Evaluation of the report by Tokyo Electric Power Company regarding the leakage from piping transferring water treated at the Multi-nuclide Removal System (ALPS) at the Fukushima Daiichi Nuclear Power Station

Nuclear Regulation Authority
15 July 2015

Figure 3. Situation of leakage on site*⁵

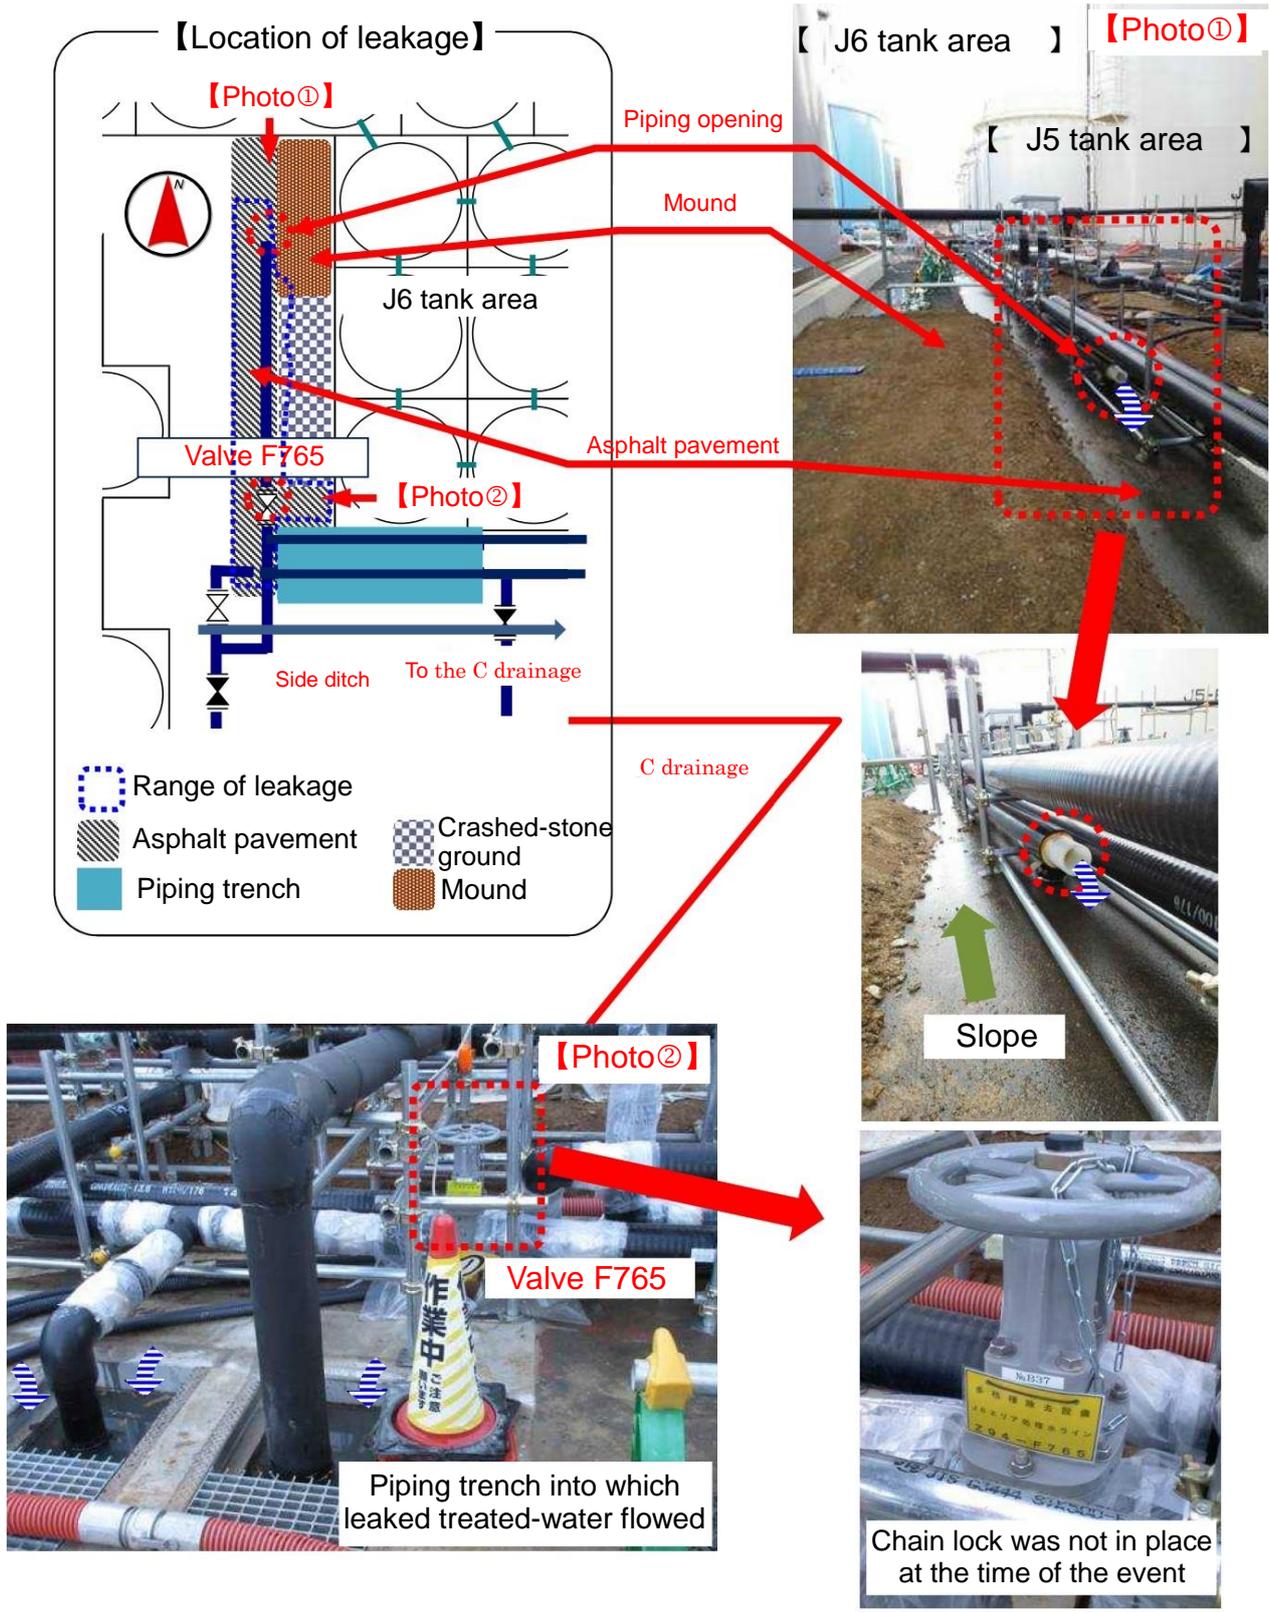
Effective dose due to γ ray and equivalent dose to skin were checked for workers who had patrolled the J6 tank area (see Figure 3). As a result, the NRA has concluded that their radiation exposure was improbable.

Figure 6. Implementation of countermeasures*⁸

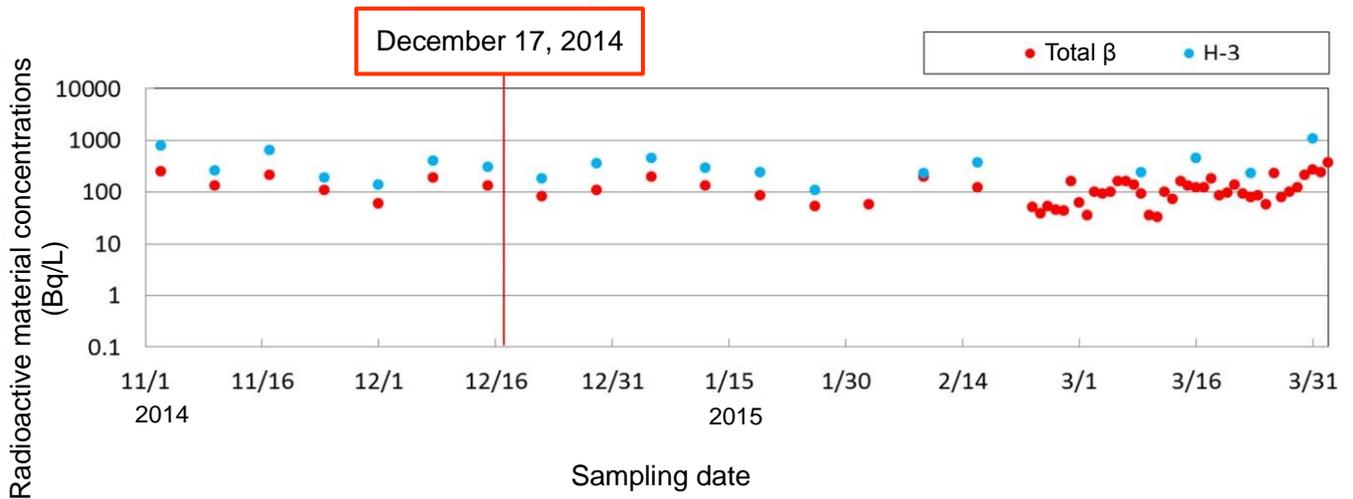
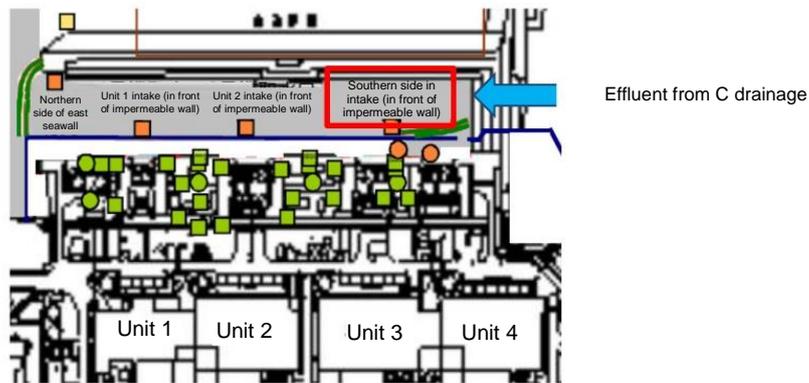
On the basis of the causes of the event, TEPCO has completed the “measure for correctly preparing a transfer manual (to prevent mistakenly recognizing transfer route),” the “measure for ensuring on-site check before starting treated-water transfer” and the “measure to avoid mistakenly opening a gate valve leading to piping under construction.” (See Table 4 and Table 5.)

The NRA has evaluated that these measures are based on the analyses and assessment of the causes of the treated-water leakage and will be effective if properly implemented. Also in the future, the NRA is going to check by means of inspections such as operational safety inspections whether the planning and implementation of work required for quality assurance program will be carried out properly.

for the first time after its construction is complete, the Construction Division shall prepare drawings clearly indicating piping routes and connections (piping system drawings [see Figure 6] or transfer route drawings) and submit them to the Equipment Management Division (implemented since February 13, 2015).

To avoid a gate valve between piping under construction and piping being used from mistakenly opened, the Construction Division shall close such a gate valve, manage its locking and provide it with a warning label (implemented since February 13, 2015) (see Figure 6).
